### STANDARDS COMMITTEE MEETING MINUTES

RE: Minutes for the September 21, 2006 Standards Committee Meeting

REVISION TO STANDARD DRAWINGS

**CLASS I DRIVE**

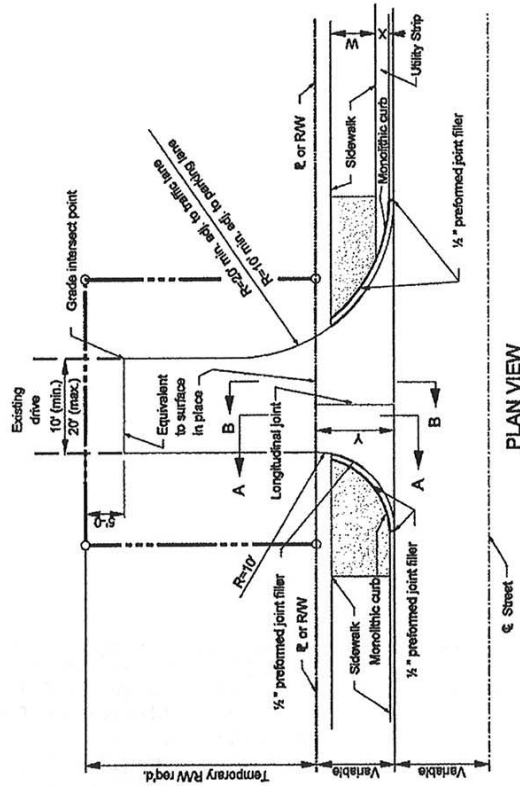
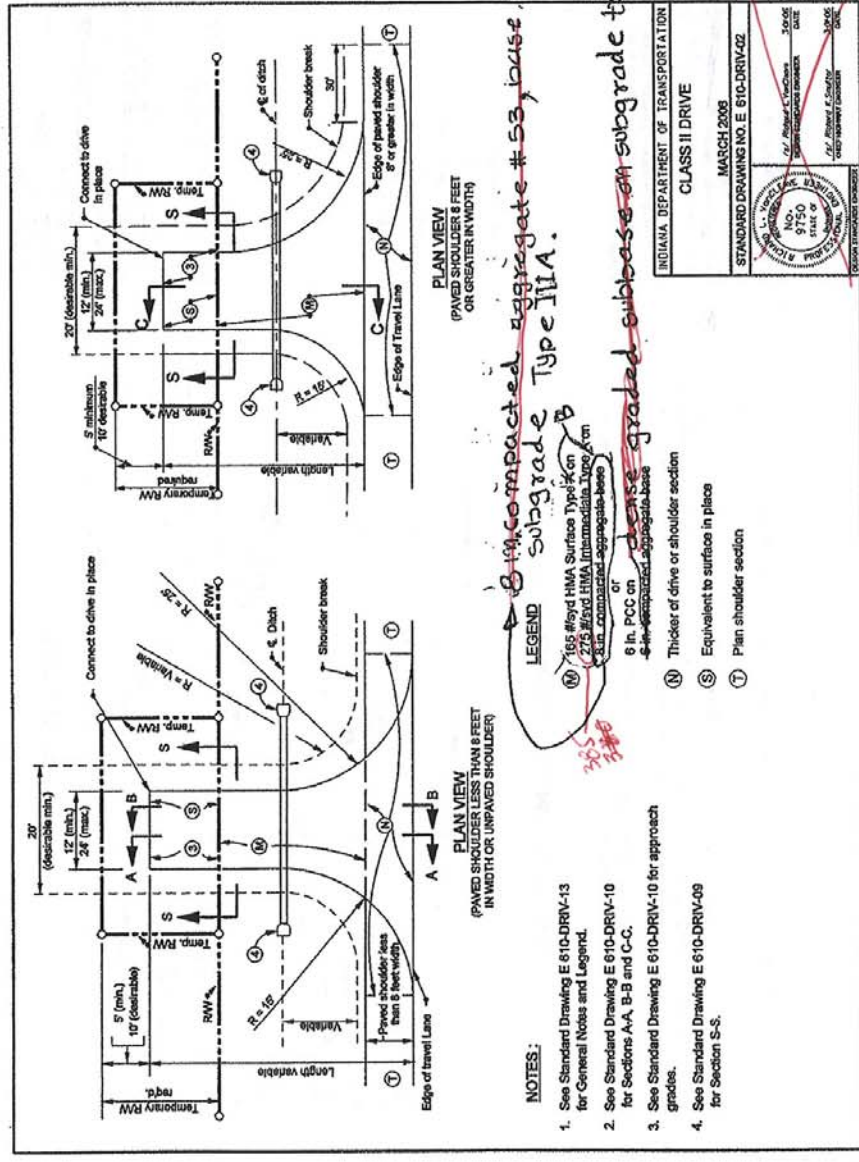
The above listed standard drawings are being revised to reflect thicker pavement sections.

~~graded~~ treatment  
Type III A.

The PCCP thickness for commercial and industrial drives is being changed from 6" PCCP on 6" compacted aggregate base to 9" PCCP on dense graded subbase on subgrade treatment Type IIIA. These drives are designed for 400 trucks per day which also accommodate a WB-65, the Indiana Design Vehicle. The corresponding changes to HMA pavement thicknesses for these drives also have been made. There is no change in the PCCP thickness for residential drives which will remain 6" PCCP thickness as shown currently on the Standard Drawings. The following Standard Drawings, both Metric and English, have been revised to incorporate the PCCP thickness changes for the construction of the drives:

INDIANA DEPARTMENT OF TRANSPORTATION	CLASS III DRIVE	MARCH 2006	STANDARD DRAWING NO. E 610-DRIV-43		3-29-06 DATE J. J. BAKER / J. BAKER CHIEF TRANSPORTATION ENGINEER
				3-29-06 DATE J. J. BAKER / J. BAKER CHIEF TRANSPORTATION ENGINEER

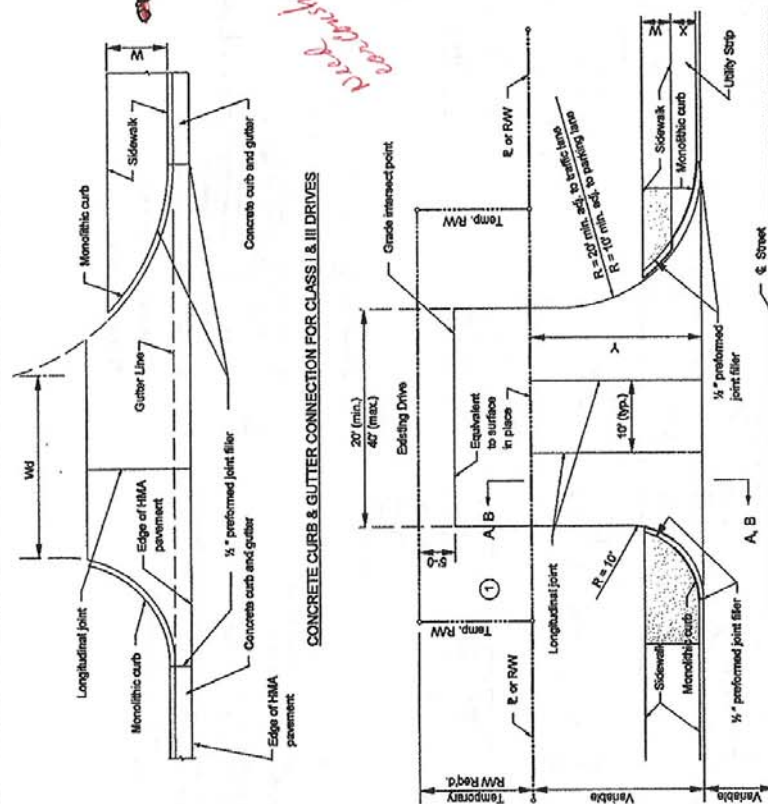
- ① See Standard Drawing E 610-DRN-08 for Section A-A, and Section B-B.
2. For Class III drive, ~~per~~ **5 in PCF** pavement for driveways shall be placed ~~on~~ **on subgrade** ~~separate base~~.
3. See Standard Drawings E 604-SDWK-01 or E 604-SDWK-02 for side walk elevation transition details, or Standard Drawing E 604-SWCR-06 for sidewalk curb ramp details if the drive is signalized.

CLASS VII DRIVE

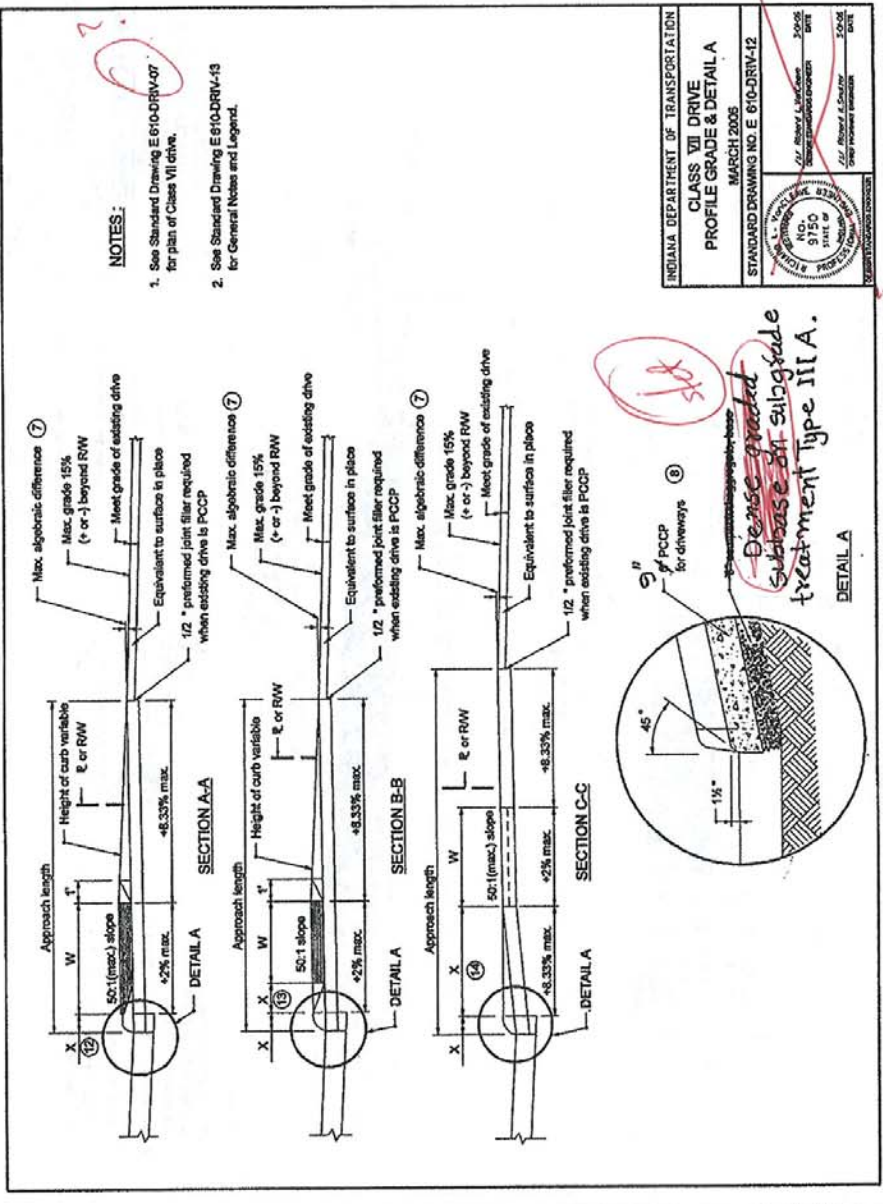
*This is not a duplicate of 15 & 16*

*Work is to type VII. 2*

*Dense graded subbase or subgrade treatment type III A.*

INDIANA DEPARTMENT OF TRANSPORTATION	
COMMERCIAL DRIVE CROSSOVERS	
PLANS	
JANUARY 2000	
STANDARD DRAWING NO. E 610-DRIV-19	
PREPARED BY No. 18055 DESIGNER No. 18055 CHECKED BY No. 18055 DATE 1-03-00	No. 18055 DATE 1-03-00

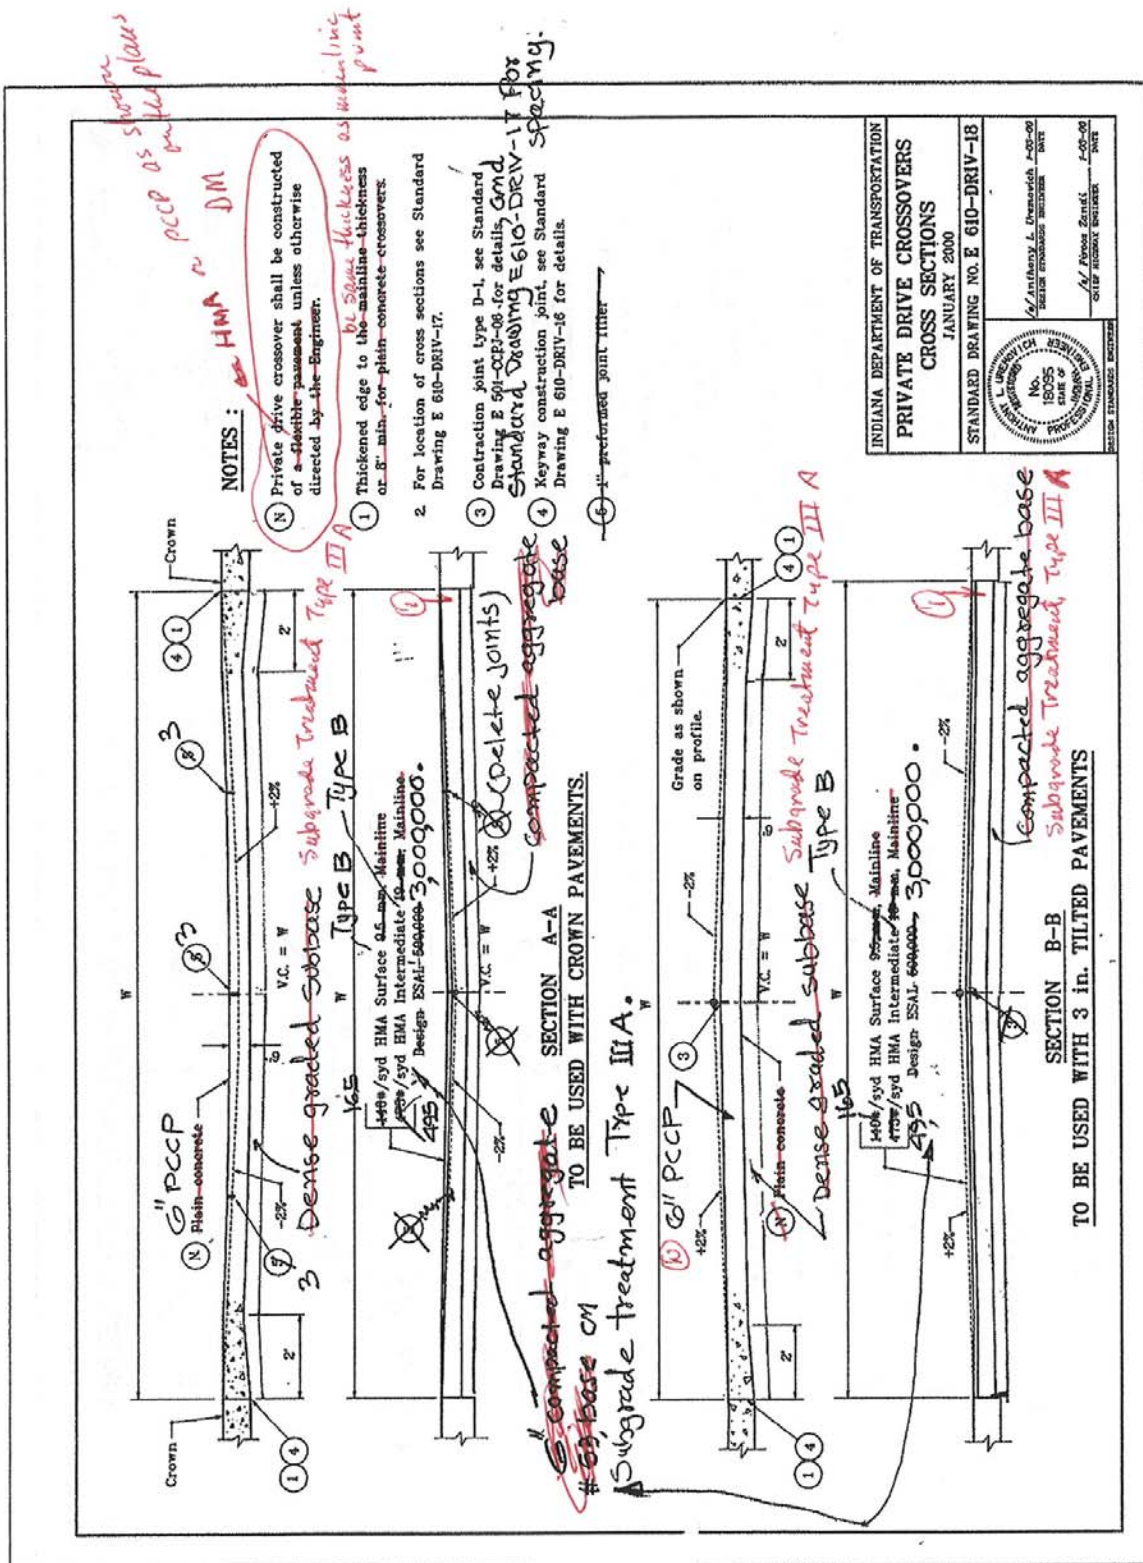
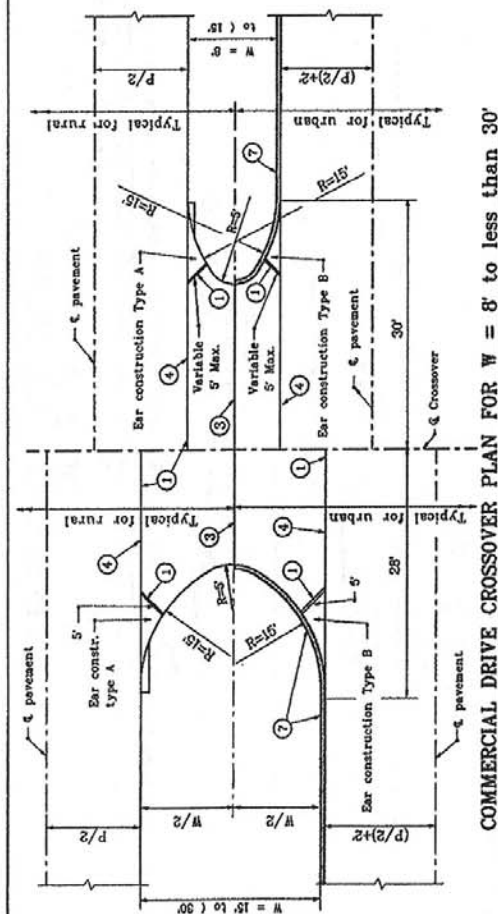
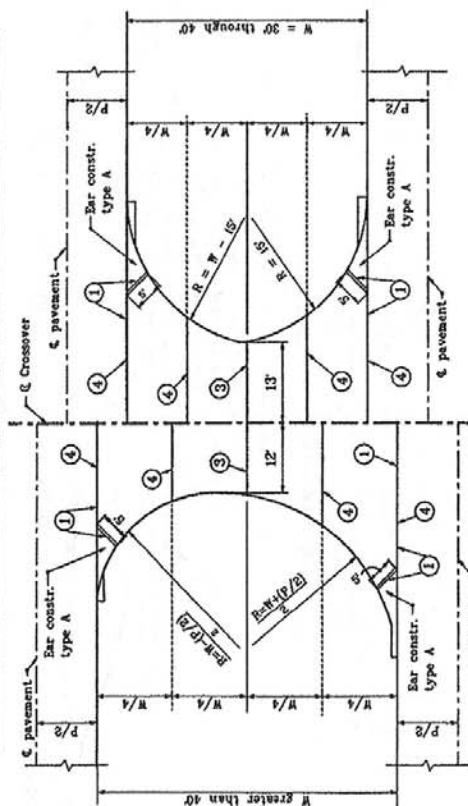
1. Thickened edge ~~on PCCP~~
2. See Standard Drawings : "A" ear construction E 605-ERCN-01 for TYPE "A" ear construction E 605-ERCN-02 for TYPE "B" ear construction
3. Contraction joint type D-1, see Standard Drawing E 503-CCPJ-01 for details.
4. Keyway construction joint - see Drawing E 610-DRIV-16 for details.
5. Grade ~~and cross-section~~ for commercial drive crossover shall be the same as for private drive crossover, ~~except that the  $R = 15'$  shall be  $R = 10'$~~
6. For cross sections see Standard Drawing E 610-DRIV-16, ~~except the PCCP thickness shall be 9 in.~~
7. Integral concrete curb, see Standard Drawing E 605-CCIN-01 for details.
8. Commercial drive crossover shall be constructed of a flexible section unless otherwise directed by the Engineer.

*an HMA on PCCP as shown on the plans*
